TRANS/WP.29/977
9 February 2004

**DRAFT SUPPLEMENT 6 TO THE 01 SERIES OF AMENDMENTS
TO REGULATION No. 52**

(Small capacity passenger vehicles, M2 and M3 category)

"Figure 7

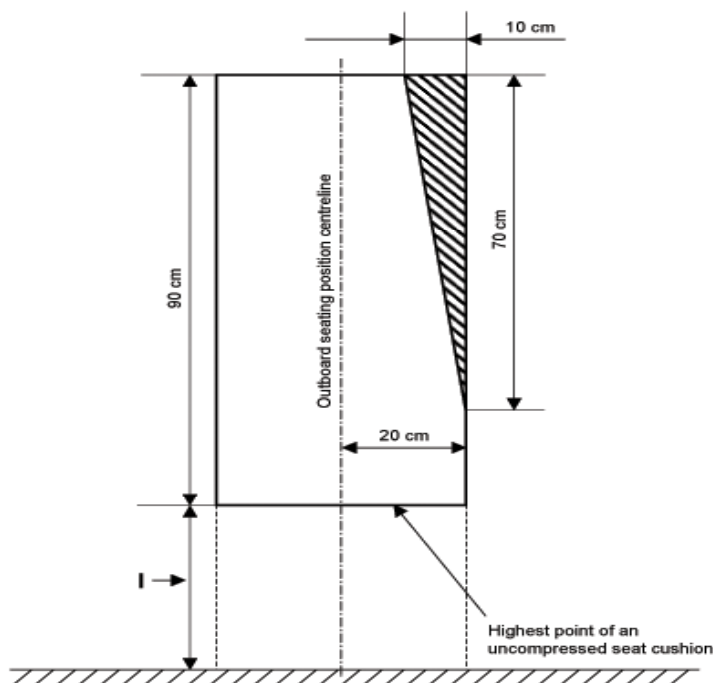
"5.7.8.1.3.2. Intrusion of a structural member provided that the intrusion is included within a triangle whose peak is situated 70 cm from the top and whose base 10 cm in width and situated in the upper part of the space in question, adjacent to the side wall of the vehicle (see annex 3, figure 7)."

Annex 3, figure 7., amend to read:

Permitted intrusion of a structural member
